Access Compliance Report

Public Rights-of-Way

(Curb Ramps)

Intersection ID: 8380	Main Street: CENTRE_ST	Cross Street: TENNESSEE_AV	Location: W
ADA ID: 1C6005C6A8F9	Ramp Type: PerpDiag	Initial Pass/Fail: Fail	Overall Compliance: No
Severity Score: 21.25			
Codes/Mitigation Info/Possible Solution		Field Measurements/Component Compliance

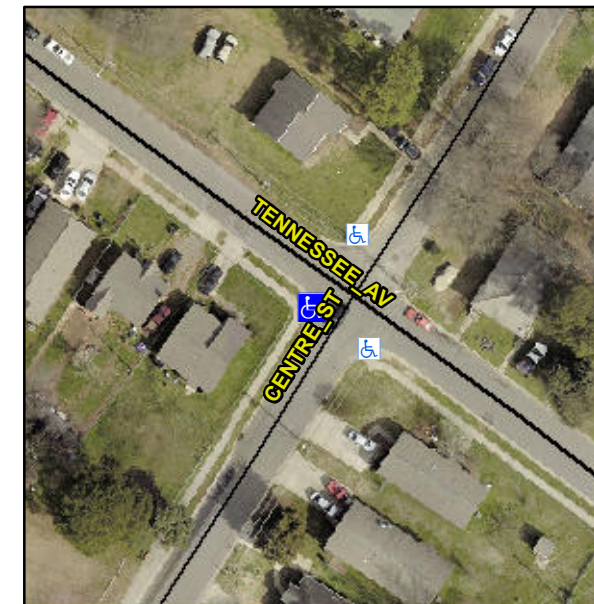
Not Found, R304.5.1, R304.5.3

Compliance	Description	Data	Compliance	Description	Data
N/A	Ramp Length (in)	108.0	Yes	Ramp Slope (%)	6.2
No	Ramp Width (in)	44.0	No	Ramp XSlope (%)	6.6
N/A	Flare Type LT	N/A	N/A	Flare Type RT	N/A
N/A	Flare Slope LT (%)	N/A	N/A	Flare Slope RT (%)	N/A
N/A	Flare Traversable LT?	N/A	N/A	Flare Traversable RT?	N/A
N/A	Landing Length (in)	N/A	N/A	DWS Provided?	N/A
N/A	Landing Width (in)	N/A	N/A	DWS Contrast?	N/A
N/A	Landing Slope (%)	N/A	N/A	DWS Length (in)	N/A
N/A	Landing X Slope (%)	N/A	N/A	DWS Full Width?	N/A
N/A	Landing Curb? (Y/N)	N/A	N/A	DWS Offset (in)	N/A
N/A	Shared Landing?	N/A			
N/A	Gutter Ponding?	N/A	N/A	Gutter Slope (%)	N/A
N/A	Gutter Lip Ht (in)	N/A	N/A	Gutter X Slope (%)	N/A
N/A	Painted X Walk1?	No	N/A	Painted X Walk2?	No
	X Walk 1 Direction	To SE		X Walk 2 Direction	To NE
N/A	X Walk 1 Width (in)	N/A	N/A	X Walk 2 Width (in)	N/A
	X Walk 1 Slope (%)	3.3		X Walk 2 Slope (%)	3.1
	X Walk 1 X Slope (%)	2.8		X Walk 2 X Slope (%)	1.9

Remove & Replace Curb Ramp With Two New Directional Ramps or Equivalent.
